FROM: Allied Engineering, Inc.
160 Veranda Street
Portland, Maine 04103
Telephone: (207) 221-2260

RE: Addendum No. **Four (4)** to the Bidding Documents for:
NEW York Vehicle Storage Garage, York, ME

This Addendum forms a part of the Contract Documents and modifies the original Bidding Documents dated March 28, 2023. Acknowledge receipt of this Addendum in the space provided on the Proposal Form. Failure to do so may subject Bidder to disqualification.

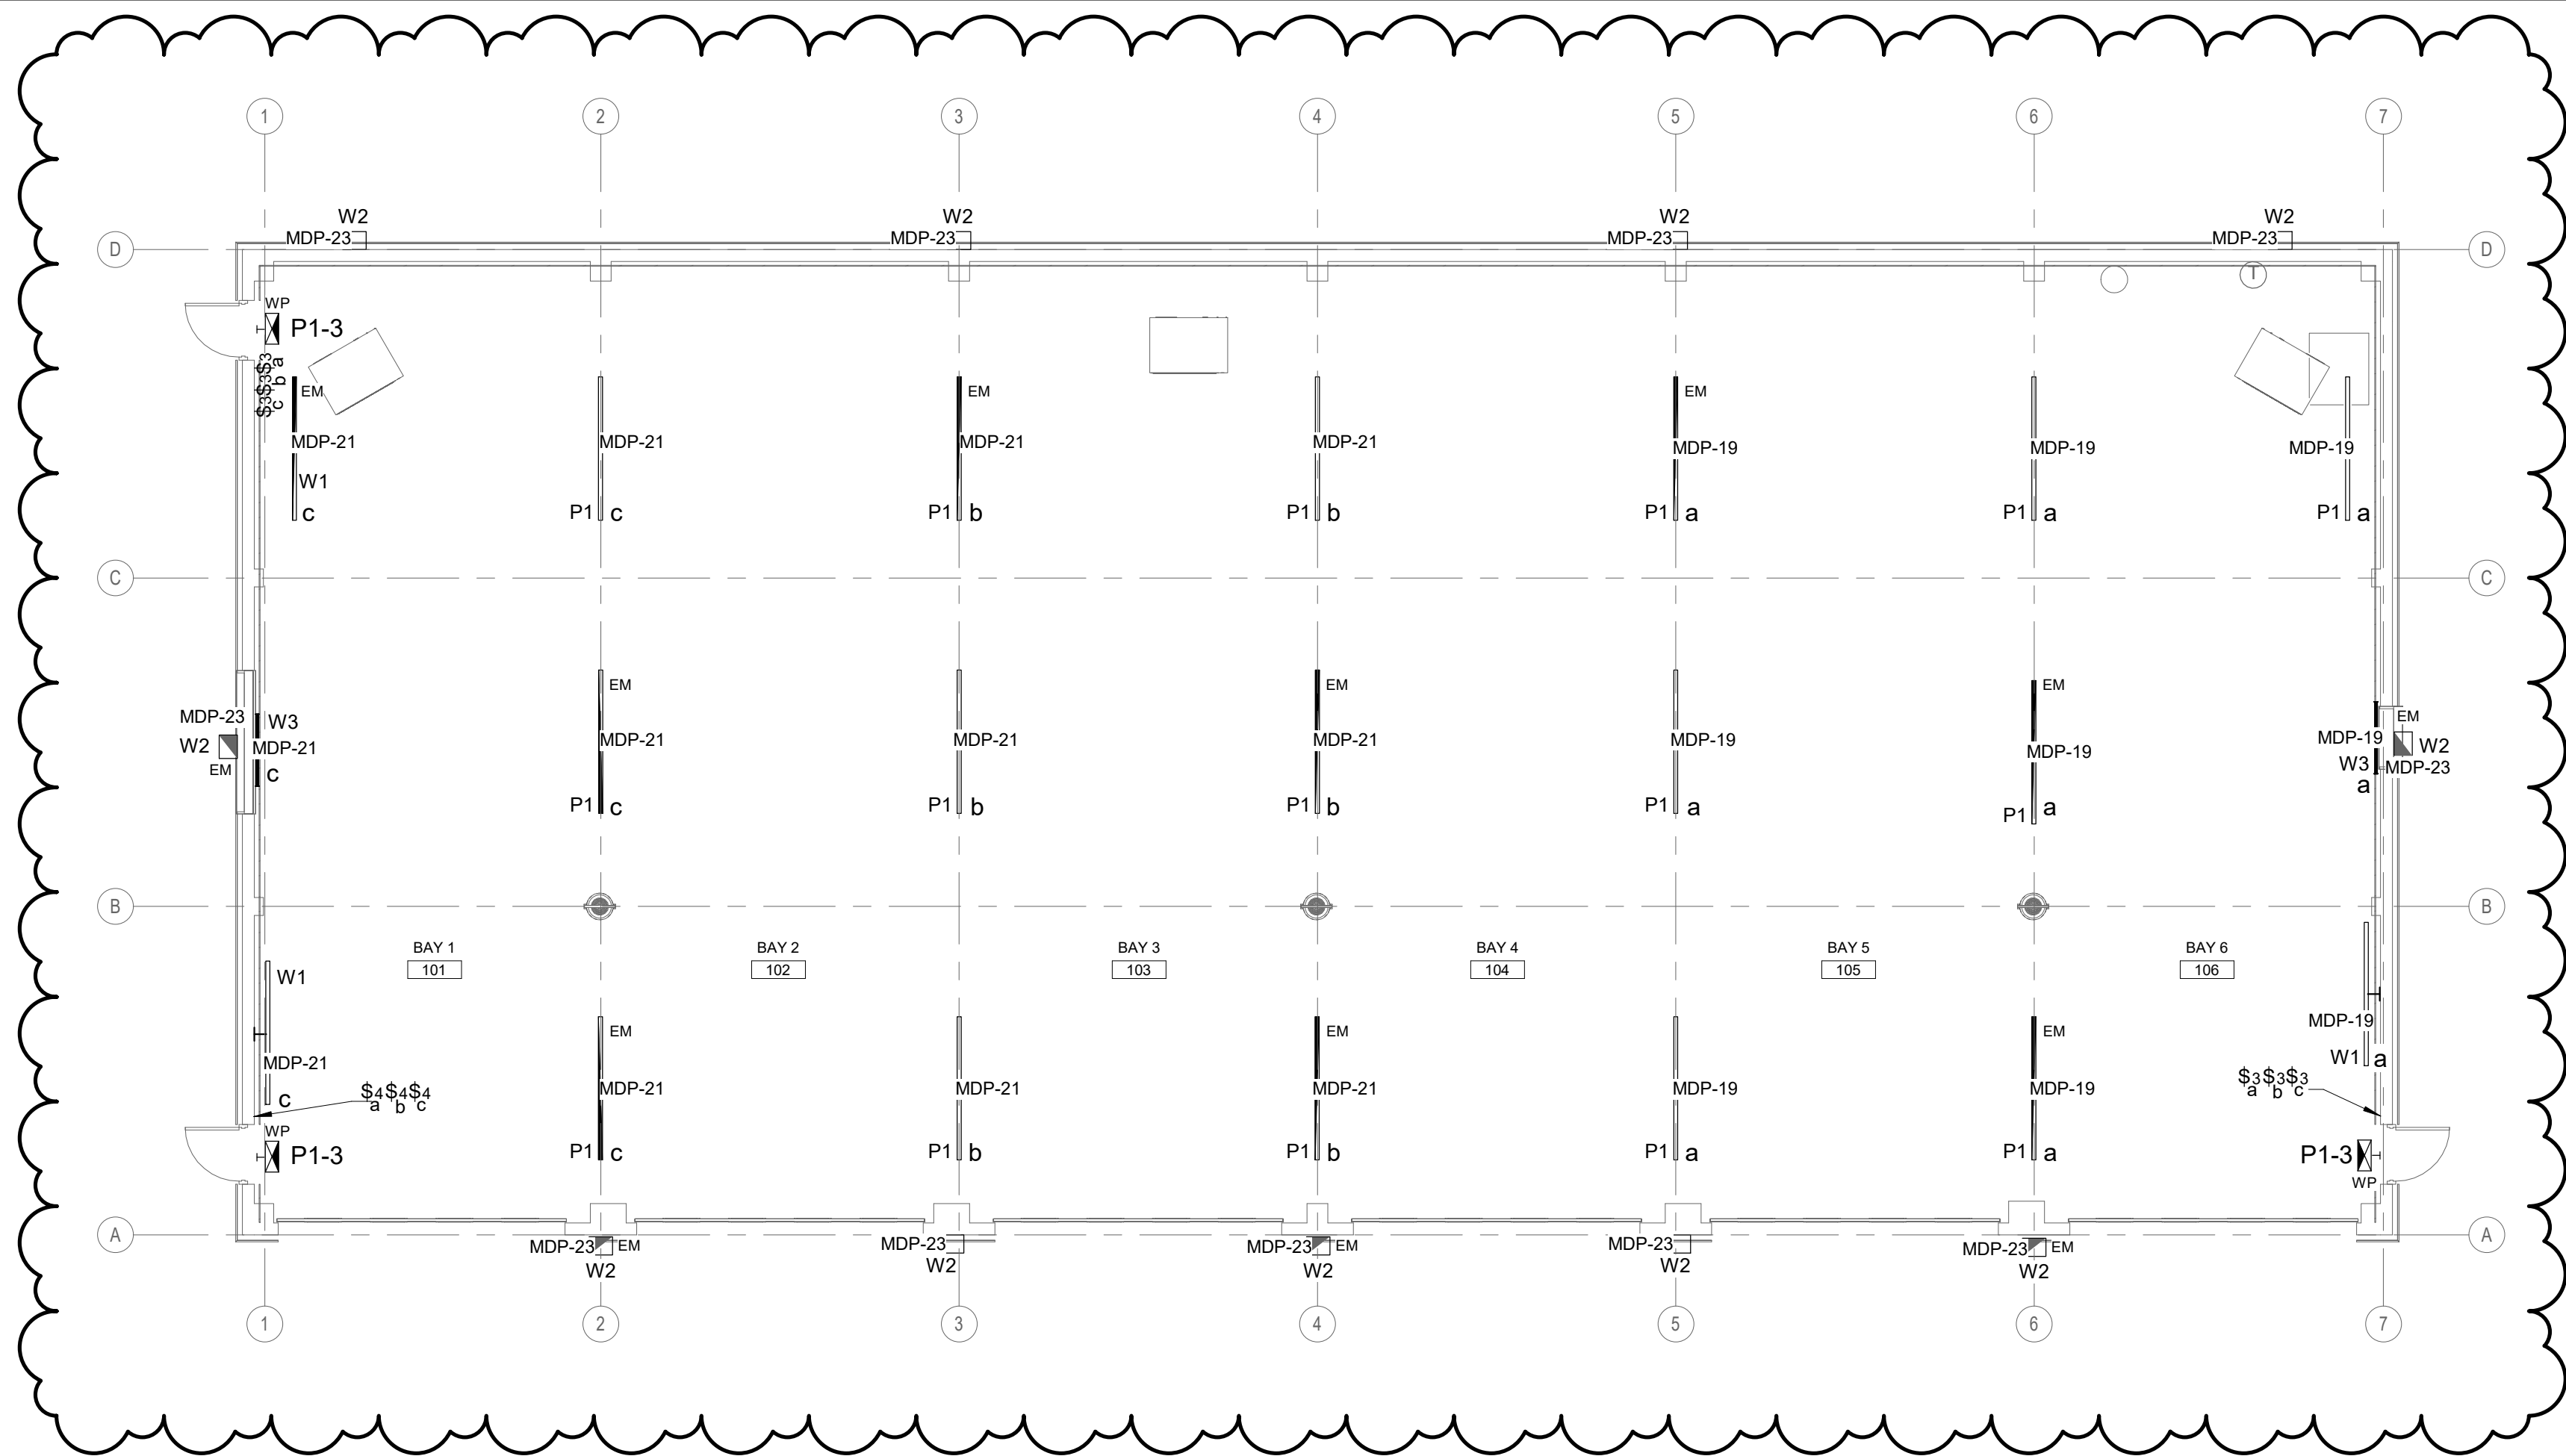
UPDATES:

- UPDATING LIGHTING CIRCUITS

ELECTRICAL SCHEDULE OF MECHANICAL EQUIPMENT- REFER TO PANEL SCHEDULES FOR CIRCUITING

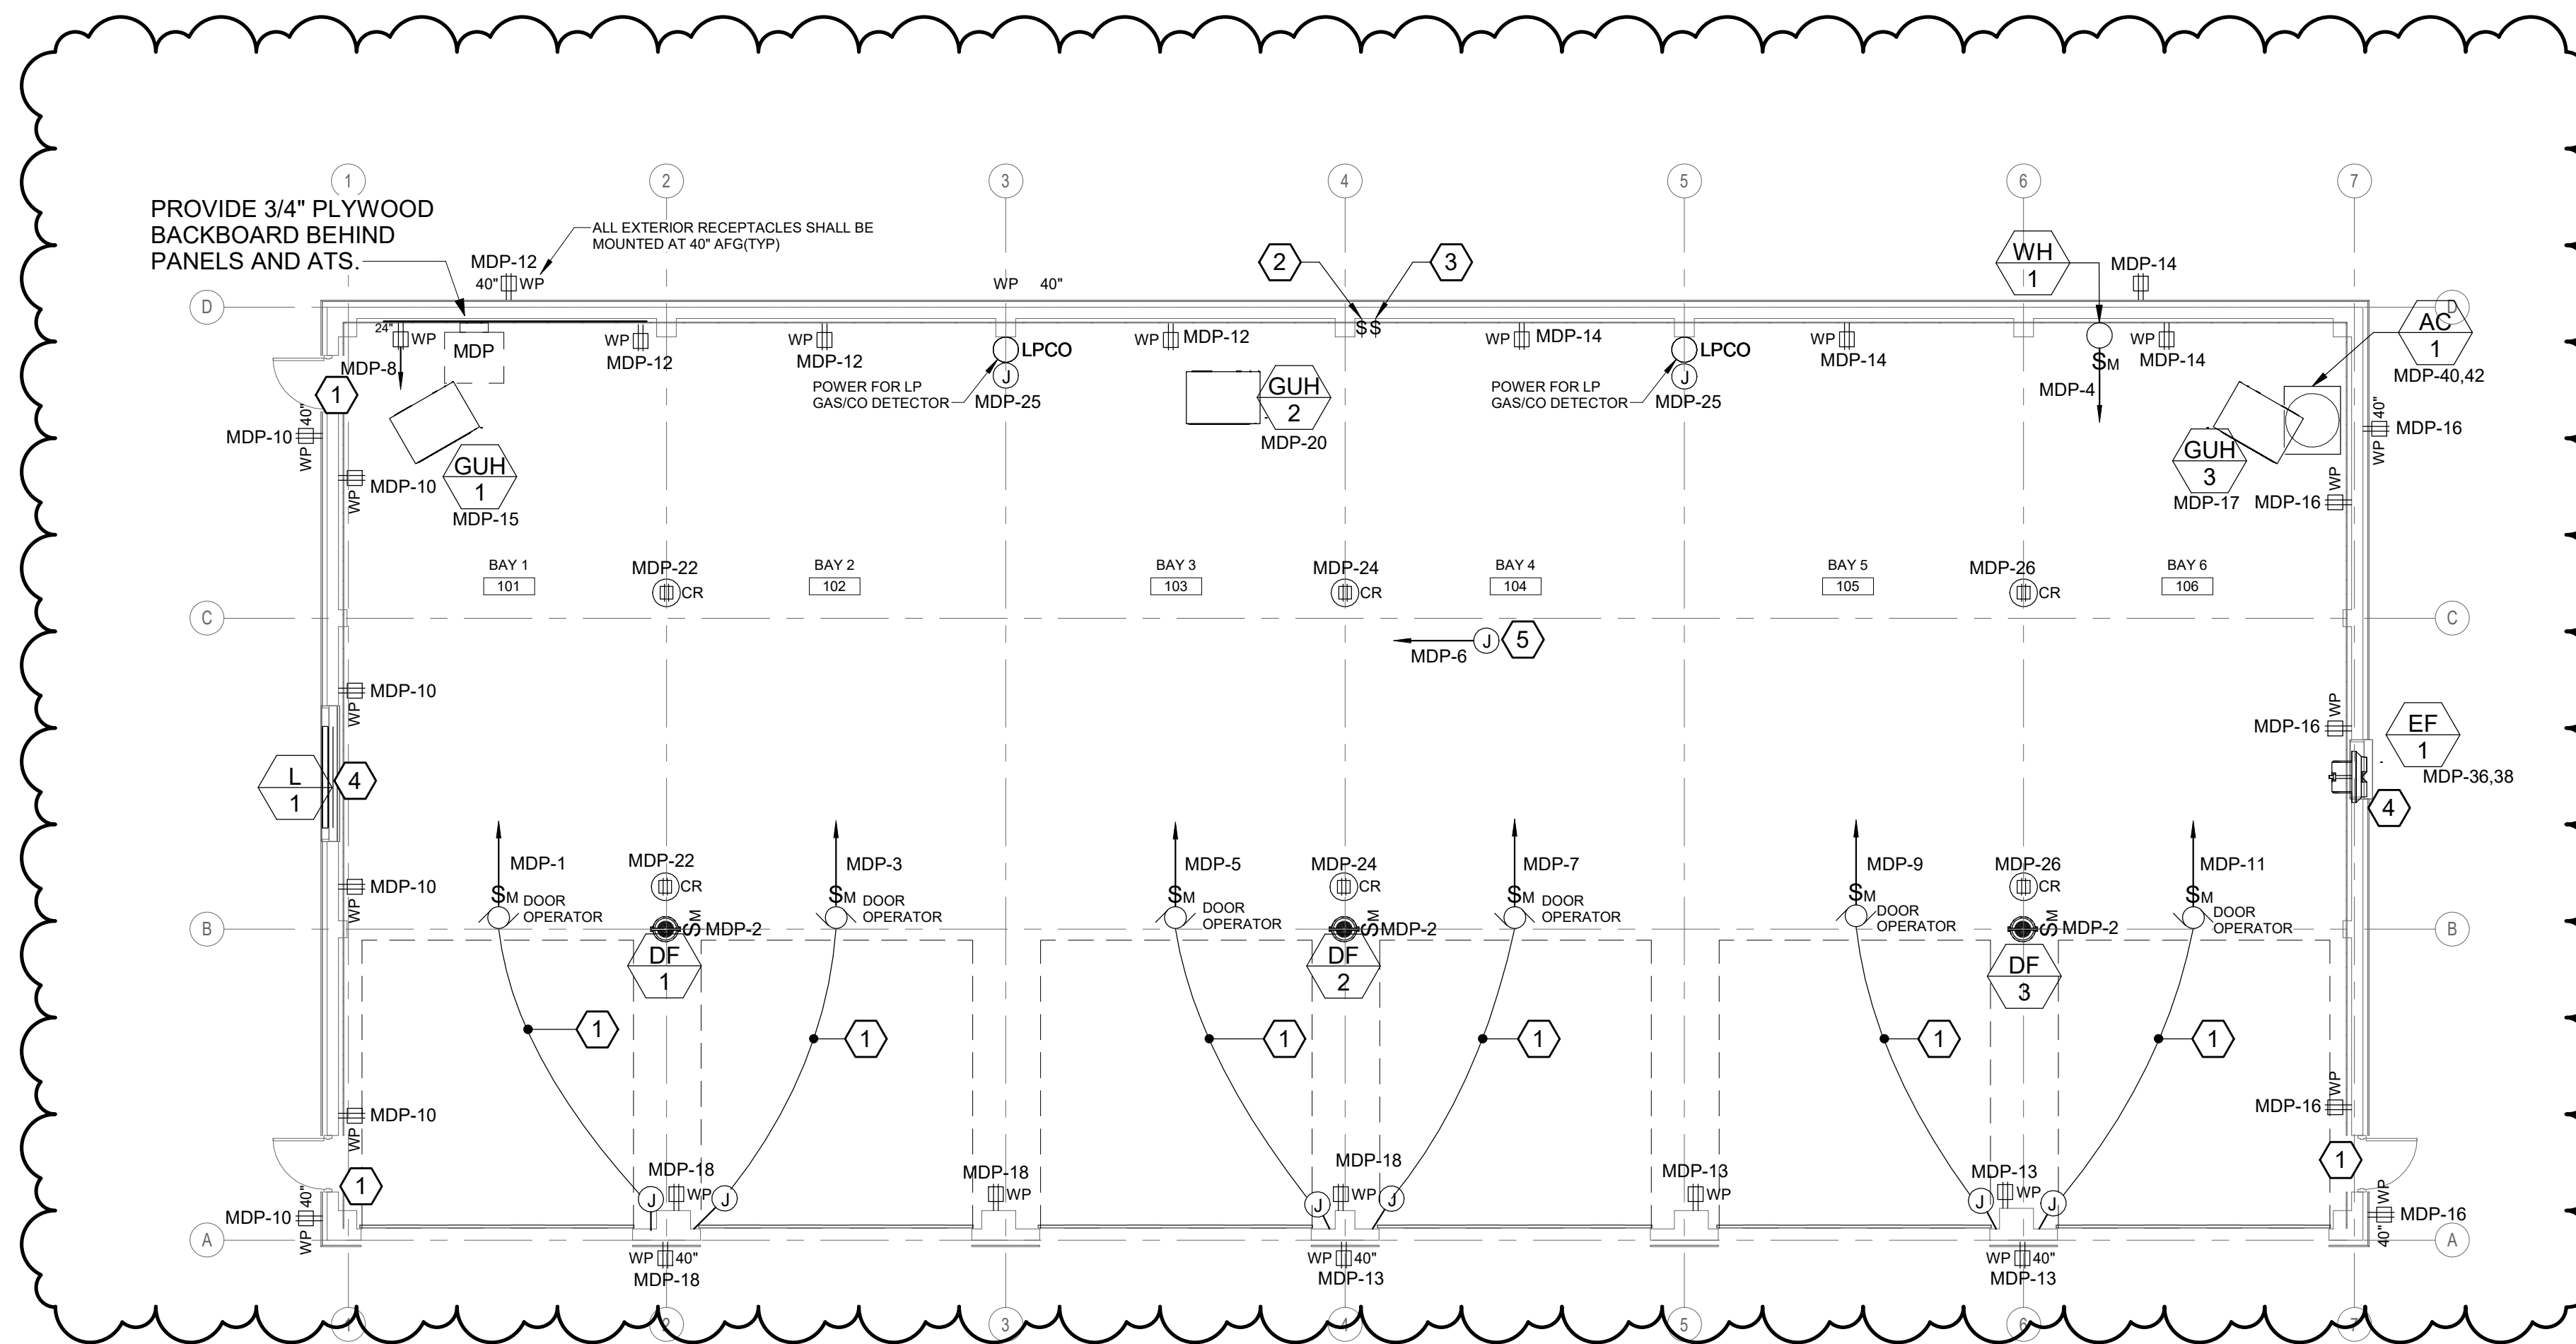
UPDATES:

- BUILDING DISTRIBUTION CHANGED FROM 208V, 3PH TO 240V, 1PH.
- UPDATED CIRCUITING
- UPDATED ELECTRICAL SCHEDULE OF MECH EQUIPMENT
- REMOVAL OF PANEL P1

SHEET NUMBER: EP500

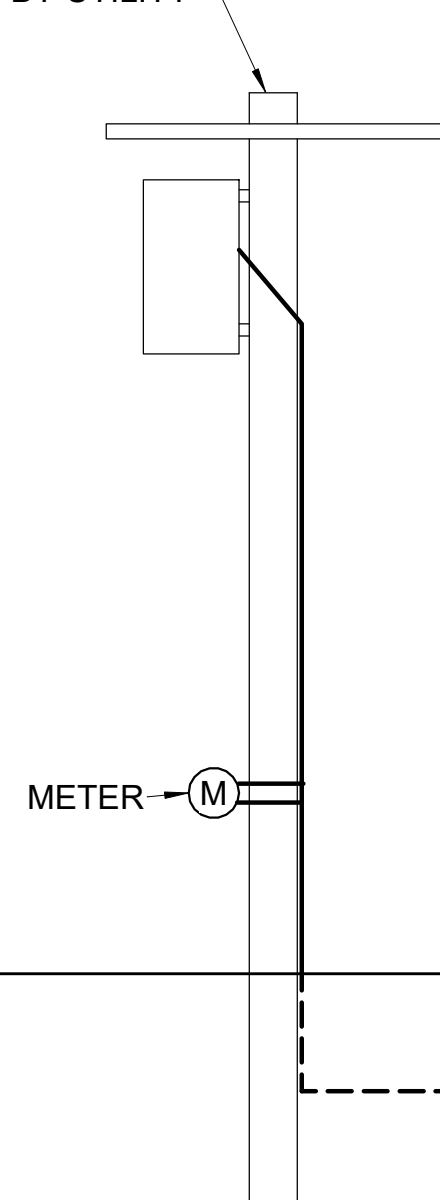
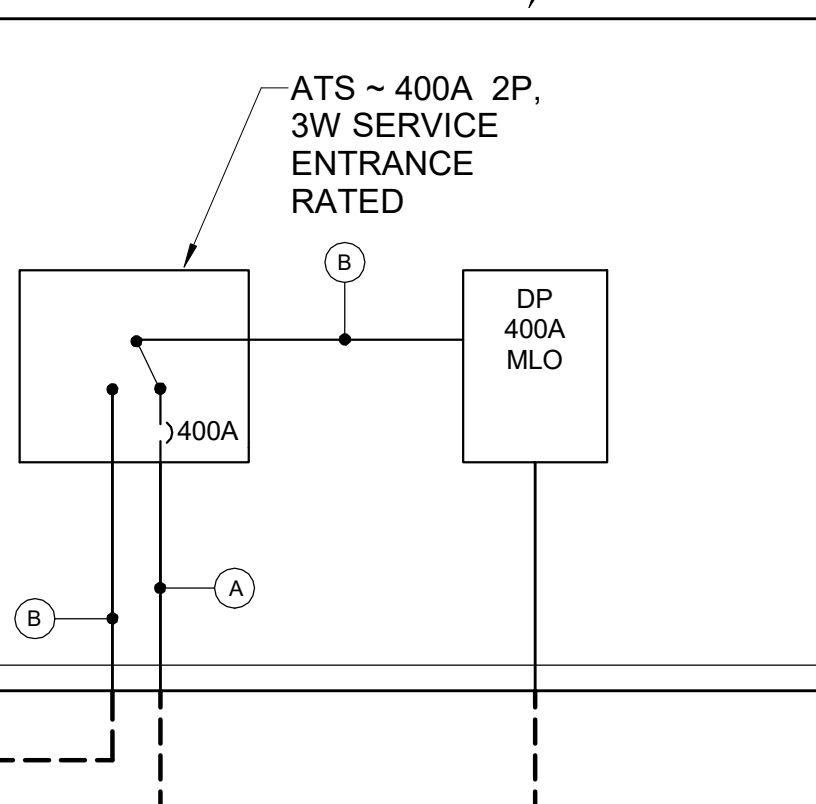
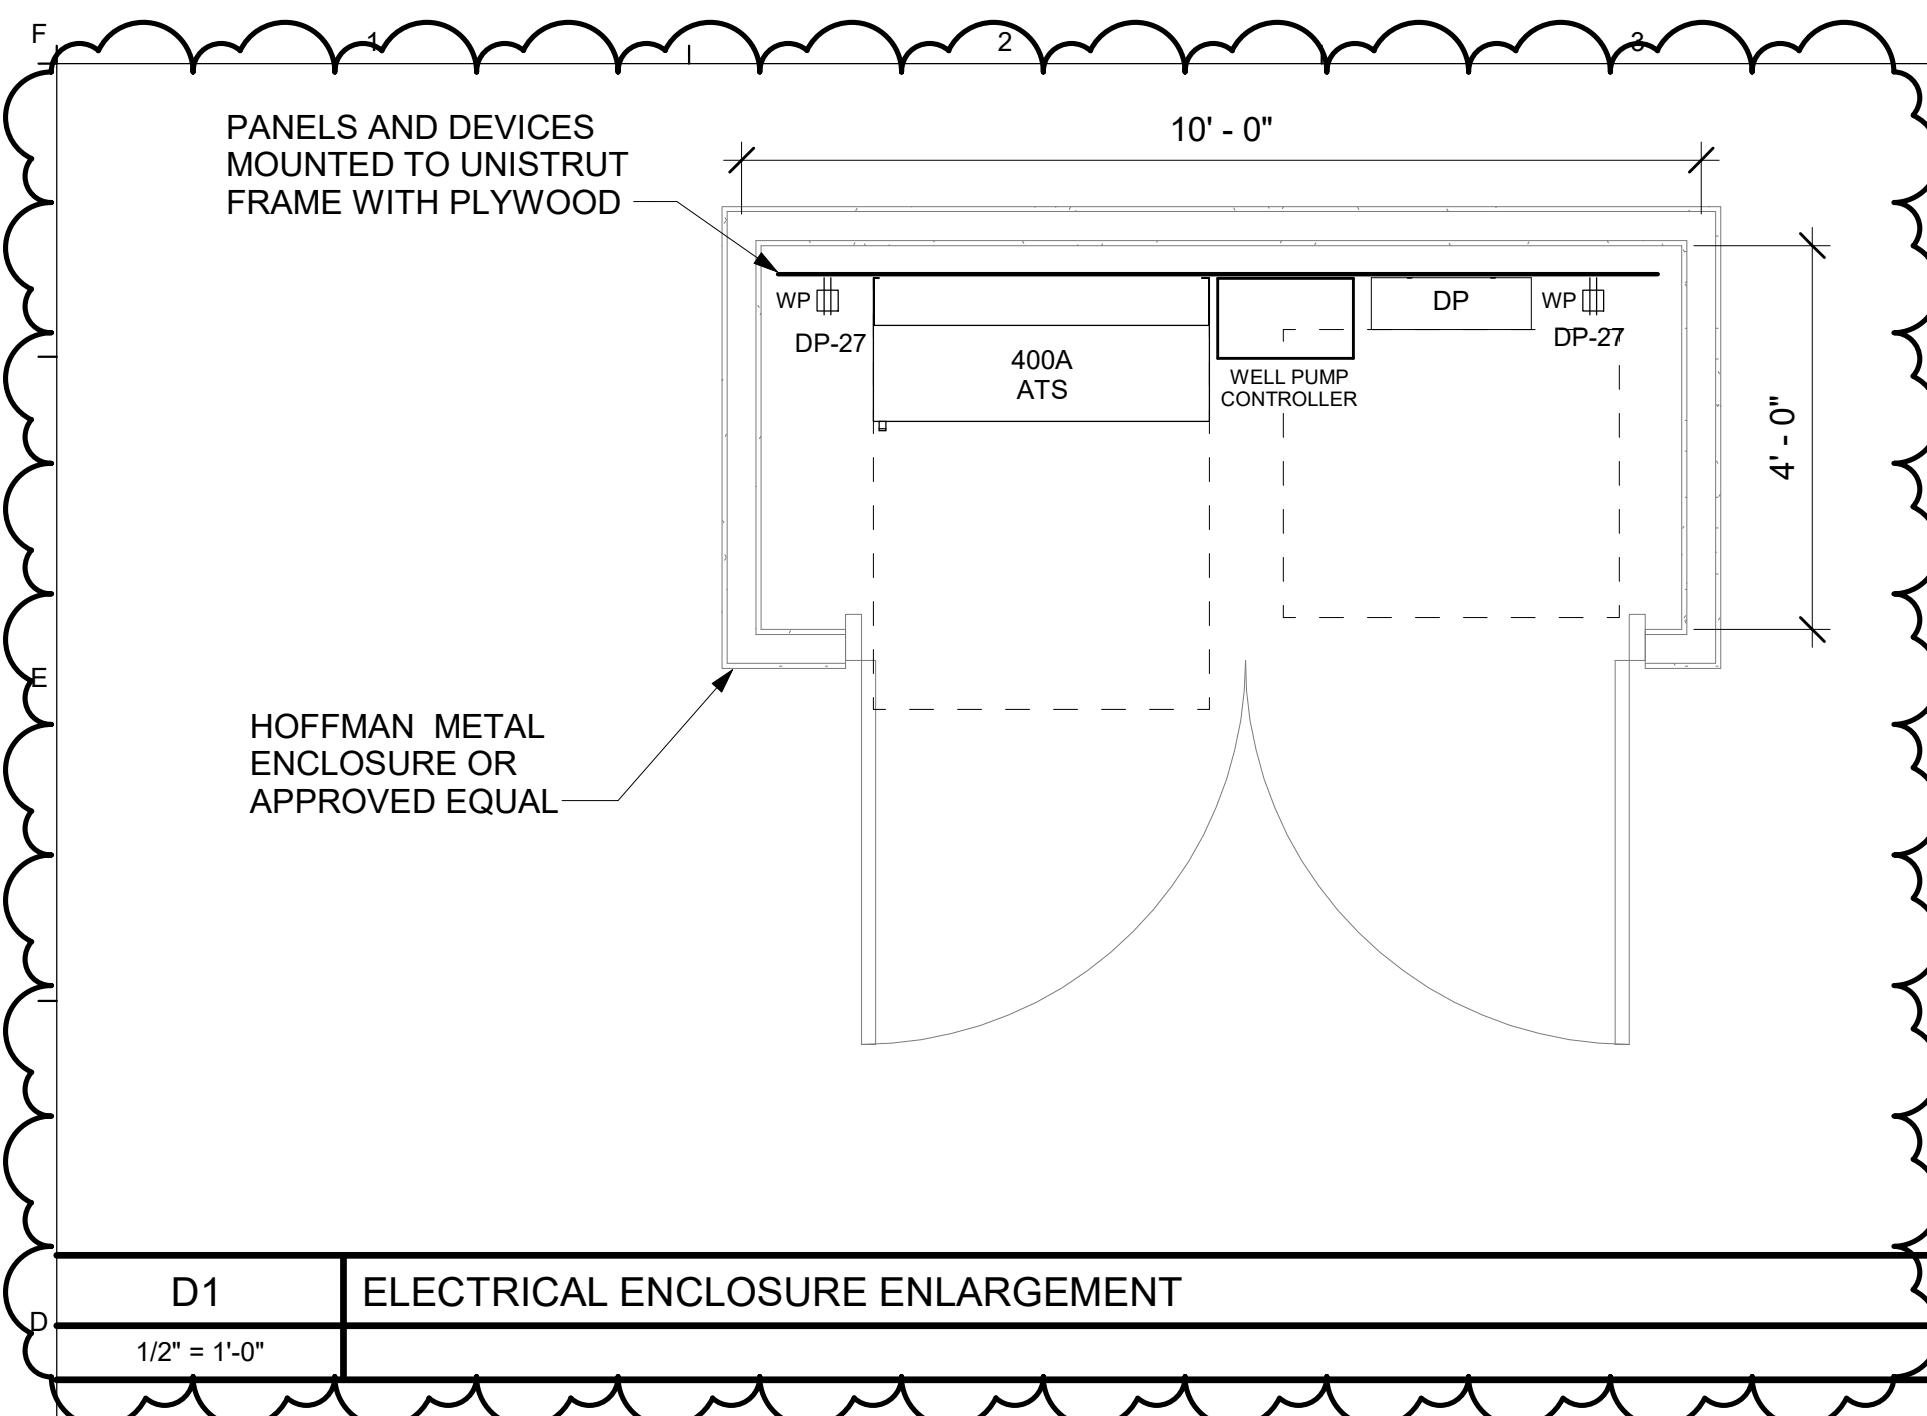
UPDATES:

- DELETED NEW UTILITY SERVICE TO THE BUILDING, BUILDING TO BE FED FROM CAMPUS MDP.
- BUILDING DISTRIBUTION CHANGED FROM 208V, 3PH TO 240V, 1PH.
- REMOVAL OF GENERATOR AND ASSOCIATED EQUIPMENT/CIRCUITS
- REMOVAL OF WELL PUMP
- ADD CAMPUS GENERATOR, ATS, PANEL DP
